Public Input No. 457-NFPA 1900-2025 [Global Input]

This is a recommendation from the NFPA 1900 Pump Task Group.

**Public Input No. 74-NFPA 1900-2025 [Section No. 1.1.1]****1.1.1**

Figure 11.1.3.1 Dimension Lines for Measuring Seat Belt Effective Length.

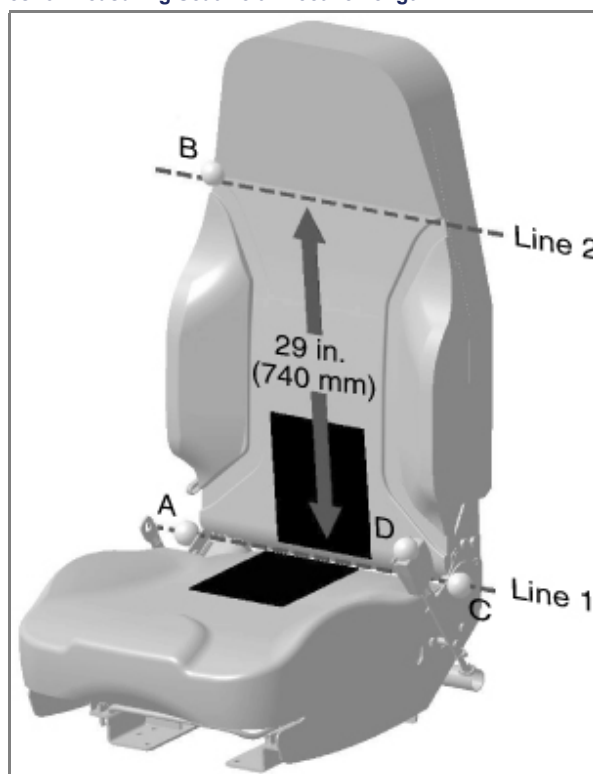
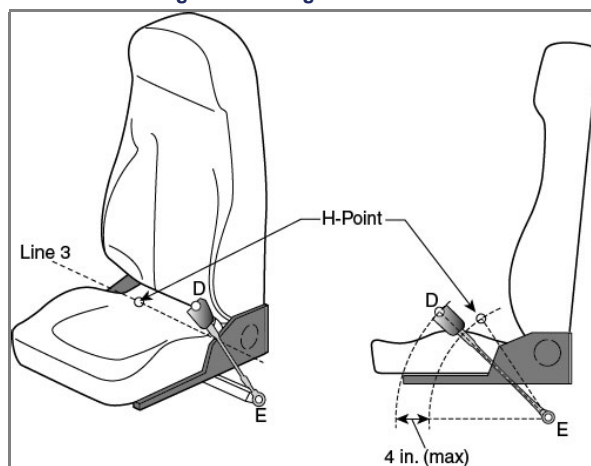
- (1) Locate an imaginary line where the plane of the center of the seat back surface intersects the plane of the center of the seat cushion surface (line 1 in Figure 11.1.3.1). For seats with an SCBA seat back, use a plane that simulates the position of an SCBA back pad installed in the SCBA holder.
- (2) Locate point A on line 1 at the outside of the seat on the retractor side of the seat.
- (3) Locate point C on line 1 at the outside of the seat on the buckle side of the seat.
- (4) Locate point D at the tip of the buckle.
- (5) Pull the seat belt webbing entirely out of the retractor and measure along the webbing between point A and the seat belt latch plate (tongue). Record this length as AD.
- (6) Measure from point C to point D and record this length as CD.
- (7) The effective seat belt web length equals AD + CD.

- (8) Measure from point C to Point D and record this length as CD.
- (9) The effective seat belt web length equals $AB + 2CD$.

Figure A.9.3.2.4 Dimensions for Determining Angle of Departure.

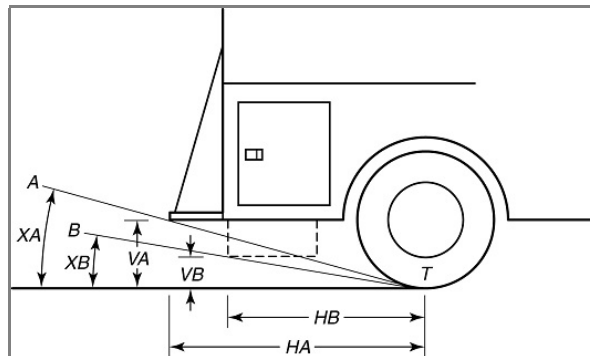
Public Input No. 212-NFPA 1900-2025 [Section No. A.9.3.2.4]

In Figure A.9.3.2.4, the line AT represents the circumstance in which the tailboard is the determining lowest point. The line BT represents a circumstance in which the tailboard is not the lowest point (in this case, the lowest point is a fuel tank). The angle of departure is shown as XA or XB . To determine the angle of departure, place a thin steel strip against the rear of the tires where they touch the ground or stretch a string tight from one rear tire to the other at the rear of where they touch the ground. Determine the lowest point (the tailboard, fuel tank, or other equipment or component) that would make the smallest angle of departure. Hang a plumb bob from the lowest point and mark the point on the ground where the point of the plumb bob touches. Measure the vertical distance from the ground to the point where the plumb bob was hung (distance V). Measure the horizontal distance from the plumb bob point to the front of the steel strip or to the string running from rear tire to rear tire (distance H). Divide the vertical distance (V) by the horizontal distance (H). The ratio of V/H is the tangent of the angle of departure. If this ratio is known, the angle of departure can be determined from a table of trigonometric functions of angles or from a math calculator. The standard requires a minimum angle of approach and angle of departure for structural apparatus of 8 degrees; since the tangent of 8 degrees is 0.1405, if V divided by H is 0.1405 or larger, the angle is 8 degrees or greater. The standard requires a minimum angle of approach and angle of departure is 8- for wildland apparatus of 20 degrees; since the tangent of 20 degrees is 0.3640, if V divided by H is 0.3640 or larger, the angle is 20 degrees or greater.

Figure A.10.7.14(a) Front and Left Side of an Apparatus with an Optical Warning System.

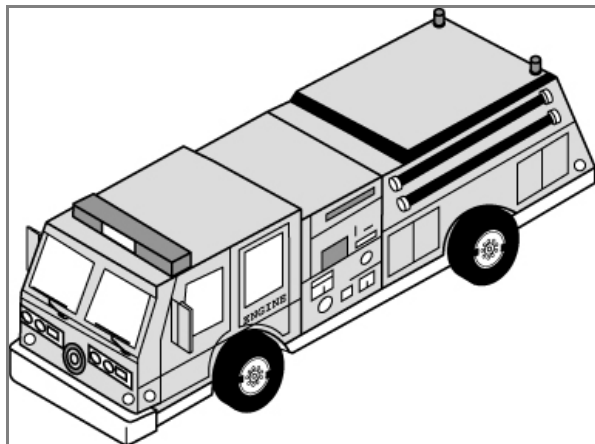
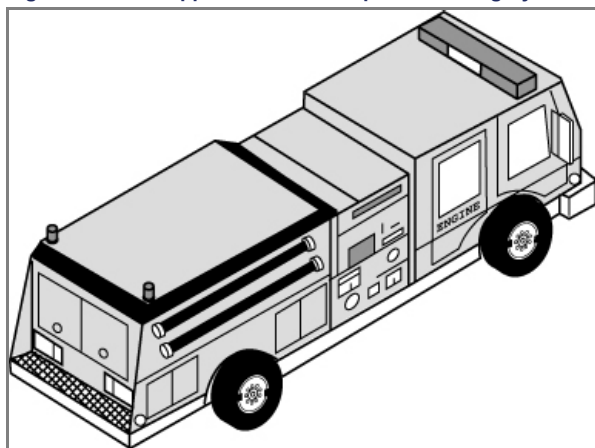
See Figure A.10.7.14(a) and Figure A.10.7.14(b) for illustrations of an optical warning system on a large fire apparatus.

Figure A.18.2.4(a) Manual Around-the-Pump Proportioning System.

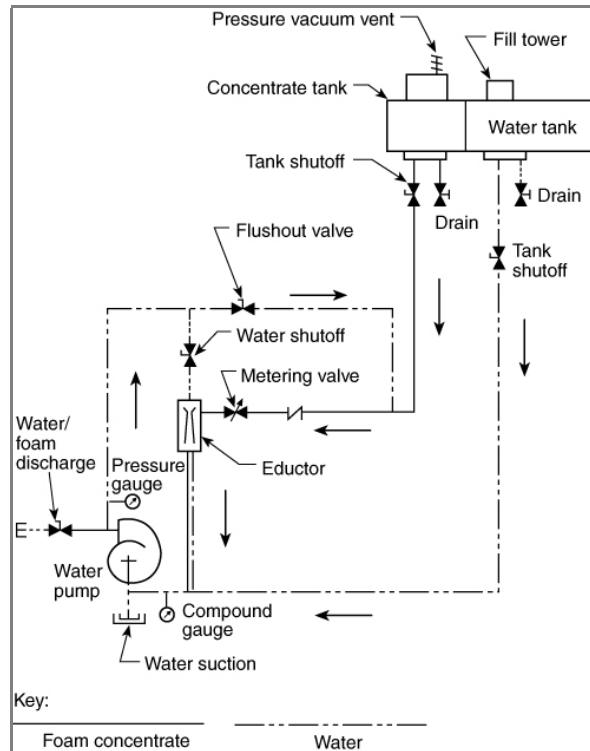
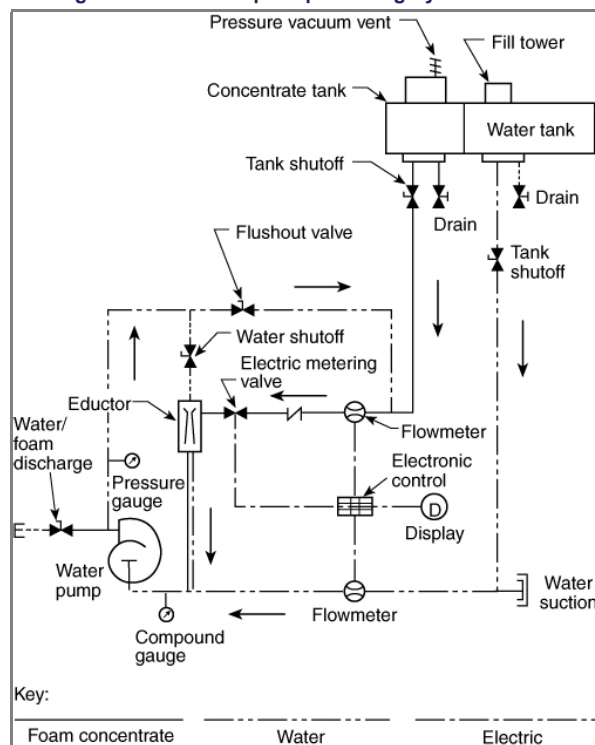
Public Input No. 218-NFPA 1900-2025 [Section No. A.18.2.4]

A manual around-the-pump proportioning system utilizes a manually adjustable foam concentrate metering valve to control the proportioning ratio. [See Figure A.18.2.4(a).]
